R. H. McCOMB ADDITION

Re: S/D97-93 -- One-Step Final Plat of R. H. McComb Addition

CASE NUMBER: S/D 97-93 - R.H. MCCOMB ADDITION

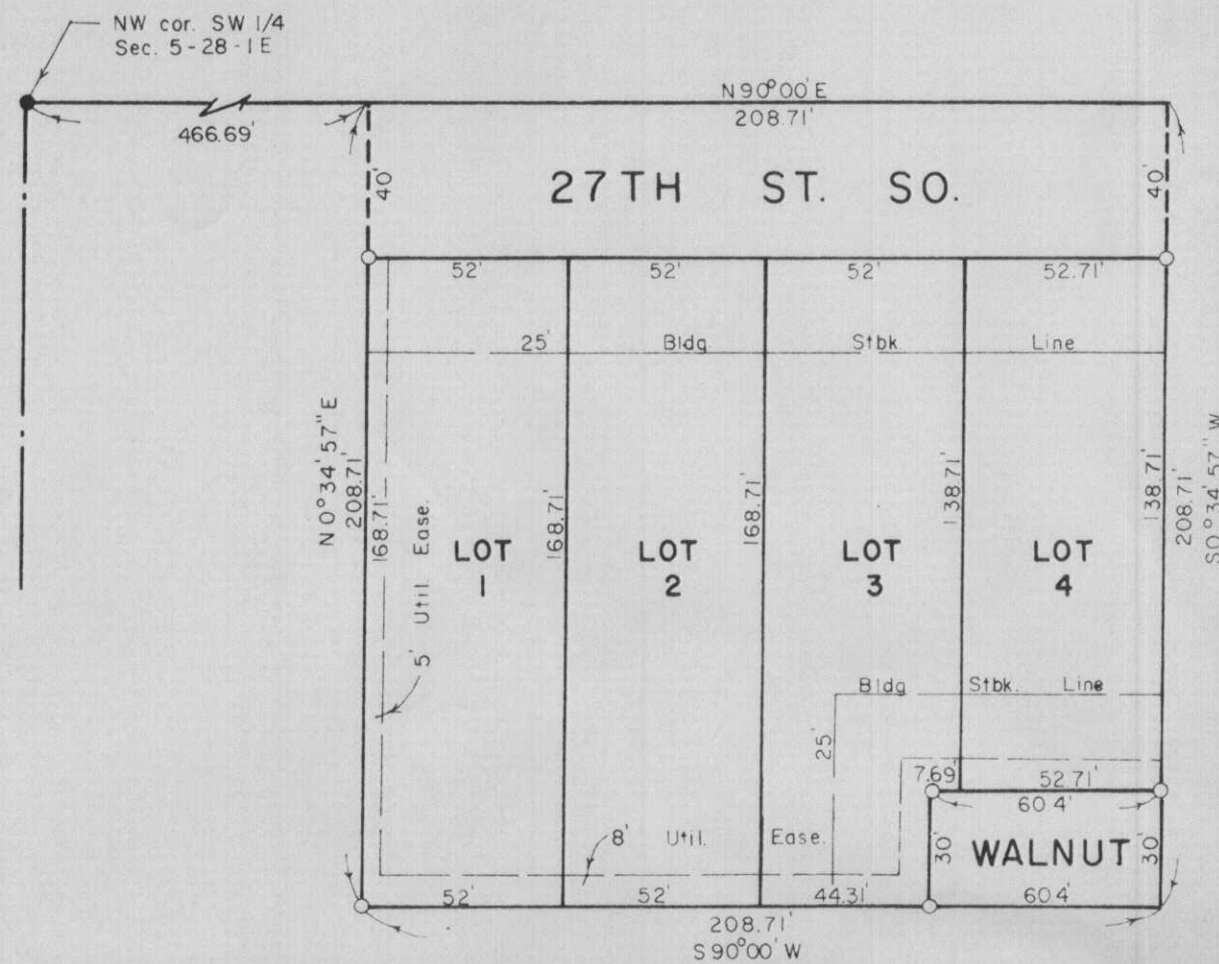
- C. The reference tie point to the section corner needs to be corrected to denote the range as "1E".
- D. This property is within a zone identified by the City Engineers' office as likely to have groundwater at some or all times within 10 feet of the ground surface elevation. Building with specially engineered foundations or with the lowest floor opening above groundwater is recommended, and owners seeking building permits on this property will be similarly advised. More detailed information on recorded groundwater elevations in the vicinity of this property is available in the City Engineers' office.

- E. City Engineering needs to comment on the status of the applicant's drainage plan. The drainage plan is approved.
- F. The lot depth to lot width ratio of 2.5 to 1 is exceeded by each of the four lots and a waiver is needed for the approval of this plat.

- G. The 15-foot setback platted from Walnut is insufficient. A 25-foot setback is required.
- H. On the final plat tracing, the Chair of the MAPC should read Richard Lopez.

- I. Since this plat is dedicating right-of-way for Walnut, the face of the plat shall clearly indicate such a dedication and appropriate language included in the plat's text. **A paving guarantee will be required for the T-type turnaround which will be held until Walnut is paved.**

- J. **Traffic Engineering and City Fire Department** needs to comment on the T-type turnaround proposed for Walnut Street which currently serves ten existing single-family dwellings south of this plat and measures 460 feet in length. **City Engineering indicates that the location of the T-type turnaround will probably necessitate a sanitary sewer easement for sewer service to Lot 4; and will meet with the applicant to discuss this issue. Traffic Engineering and Fire Department have indicated the acceptability of the turnaround.**
